# SERVICE BULLETIN

**Number:** SB0506

**Subject:** Spring Tension Adjustment on Z42, Z48, Z52, and 52 X-treme

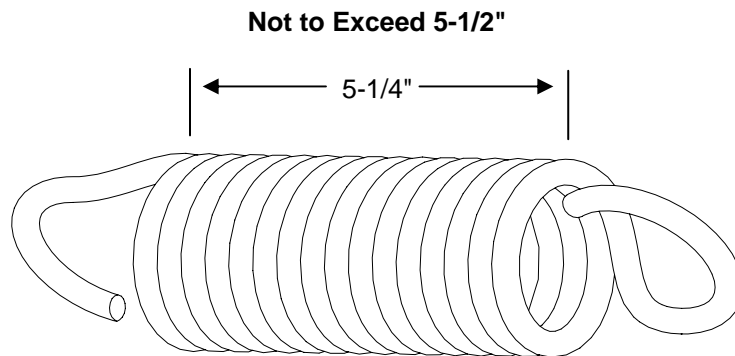
**Details:** When replacing the blade drive belt or simply adjusting the blade drive belt tension, do NOT exceed 5-1/2" of "spring stretch" measuring from coil to coil. The diagram below will illustrate where to measure the "spring stretch."

Measuring the "spring stretch" also applies when setting up new equipment.
